Technical Service Bulletin

No.JTB00053v2
09 August 2007

Subject/Concern: Whine from Rear of Vehicle at 60 mile/h (96 km/h)

Models:
S-TYPE

E94695

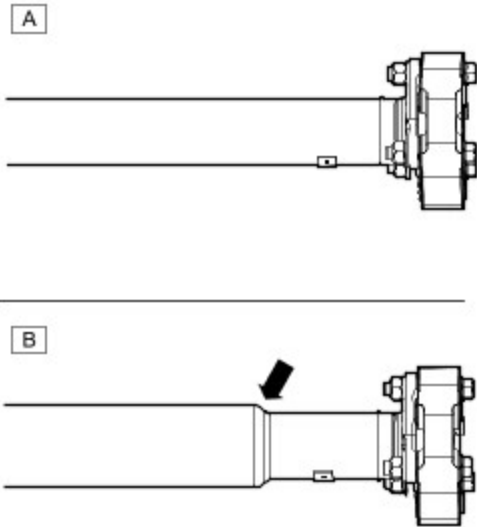
- NOTE:** The latest level driveshaft can be identified by a diameter reduction in the tube (B) approximately 150mm from the rubber coupling at the differential end of the shaft. Older level parts have a straight (A) rear tube (see E94695).

Install a new Driveshaft (see Global Technical Reference GTR Workshop Manual, section 205-02 (47.15.01)).
